Rezoning Transportation Analysis

Petition Number: 2023-080

Reviewer: Patrick Monroe
Patrick.Monroe@charlottenc.gov
704-301-1411

Revision Log:

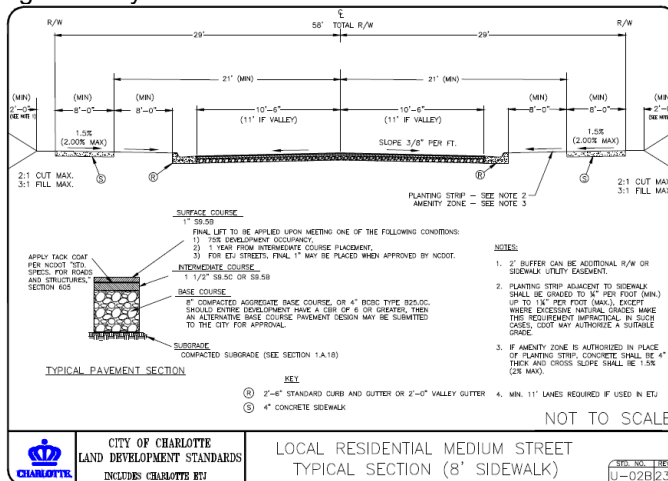
1. ~~Curbline:~~

a. ~~Forest Point Boulevard:~~ Future curb line is in the existing location

Clarifying Comment 10.26.23: From the centerline of Forest Point, label and dimension the ROW and back of curb.

b. ~~Fawn Drive Extension:~~ Street typical section is local residential medium (U-02B) with 58' of right-of-way.

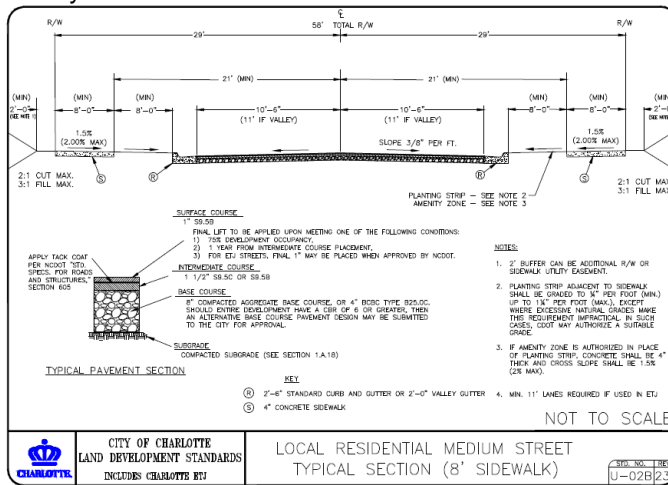
c. ~~Proposed Public Street: Cross section is local residential medium (U-02B) with 58' of right-of-way.~~

Clarifying Comment 9.20.23: U-02B should be used based on the zoning district N2 and street type.

Label and dimension the curb and gutter from the centerline for each road on the site plan.

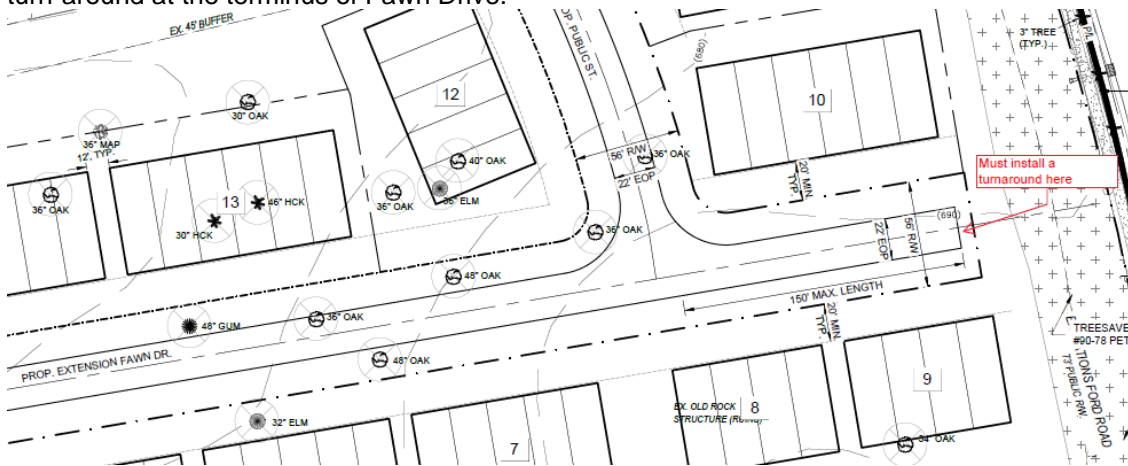
3. ~~Revise site plan and conditional note(s) to commit to construct an 8-foot planting strip, and 6-foot sidewalk on Forest Point Boulevard per UDO 32.7(D)(b)(ii); 8-foot planting strip, and 8-foot sidewalk on both sides of Fawn Drive Extension per UDO 33.3(D); and); 8-foot planting strip, and 8-foot sidewalk on both sides of Proposed Public Street per UDO 33.3(D). The site plan shall label and dimension both items from the back of curb and gutter or edge of pavement.~~

Clarifying Comment 9.20.23: 1) It is ordinance requirement, including 6' sidewalks in N1, 2) responsibility for adjustments from the ordinance requirement for sidewalk fall under the planning department and would occur during permitting 2) sidewalk cost reimbursement is available for affordable housing developments that meet the City's affordable housing criteria.
